Determination 2026/005

An authority's decision to grant a building consent under section 72 on land that is subject to a natural hazard of inundation

12 Clifford Avenue, Merivale, Christchurch

Figure 1: Position of the new dwelling & deck in relation to nearby Wairarapa Stream

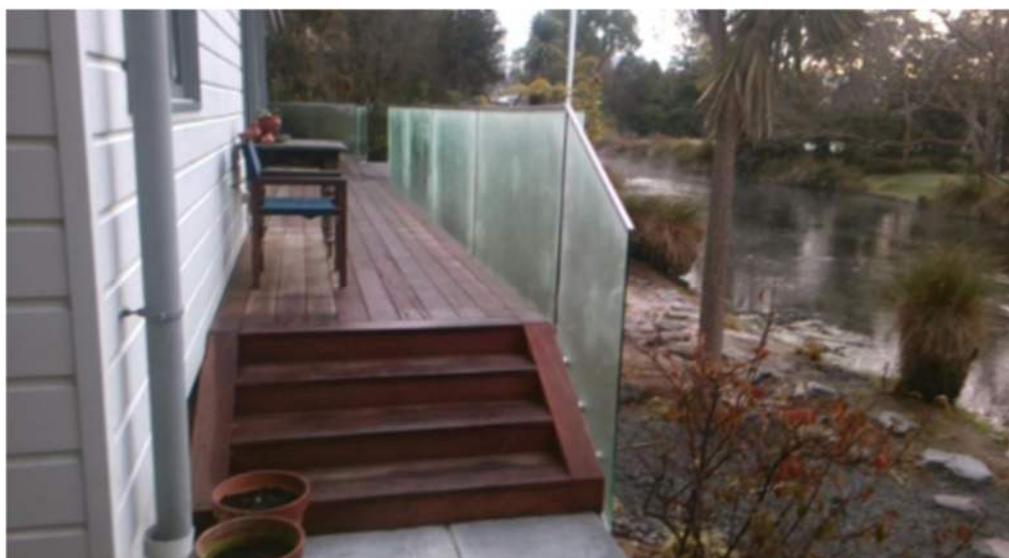
5.20. With respect to the owners' property, the source of the potential hazard is the Wairarapa Stream, which runs along the extent of the south-eastern boundary. The banks of the stream are low at <2m and sloped, with the slope continuing up under the deck. I have not been provided with exact measurements, but it would appear from the plans that the distance from the stream bank to the deck is approximately 2m, with the distance from the bank to the nearest point of the dwelling being approximately 1m more than this.

- 5.35. While the ground levels adjacent to dwelling in the area close to the stream edge are below 2% AEP levels (ranging from RL 17.47m to RL 18.00m), the dwelling's foundation has been designed to mitigate the risk of the inundation. This includes a blockwork perimeter foundation wall on a 300mm deep by 600mm-wide footing to retain the gravel raft ground improvements. In addition, a 700mm-deep waffle slab was positioned above the gravel raft to achieve the FFL of RL 18.80m along the waterway elevation of the dwelling.
